## **OPERATIONS AND MAINTENANCE PLAN GROUNDWATER TREATMENT SYSTEM BULK FUELS FACILITY SOLID WASTE MANAGEMENT UNITS ST-106/SS-111 REVISION R4**

**MARCH 2021**

Response to comments from NMED on Disapproval on the O&M Revision R3	See response to comments spreadsheet for details of requested edits (provided in Appendix A-1).

A Notice of Disapproval of the O&M Plan GWTS, BFF SWMUs ST-106 and SS-111 Revision R3 (New Mexico Environment Department, 2020) was received on December 17, 2020. This O&M Plan revision addresses the comments received from the NMED. A response to comments is provided in Appendix A-1.

FIGURE 1-1

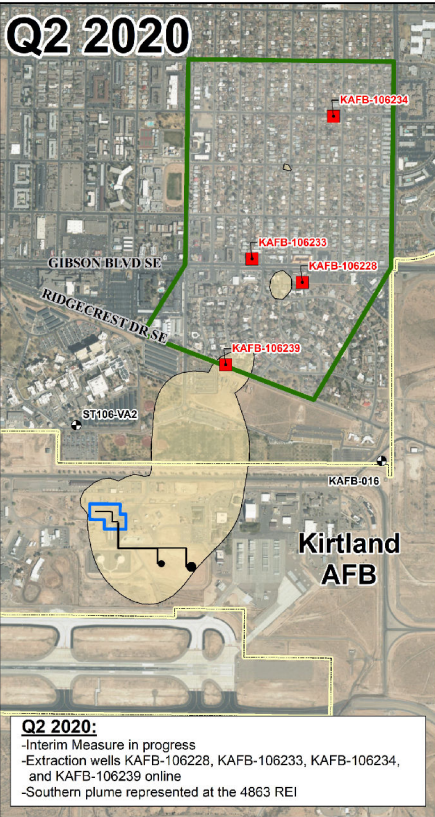
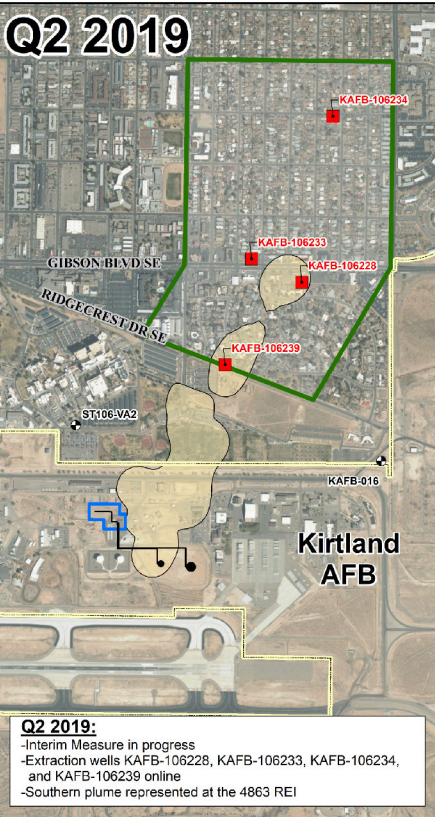
**Permittee Statement:** “Commute to the effluent changeover location shown on Figure 1-1 and close the valve where the system was previously discharging and open the valve leading to the new discharge location. It takes approximately 38.5 turns of each post indicator to completely close or open the resilient wedge gate valve.”
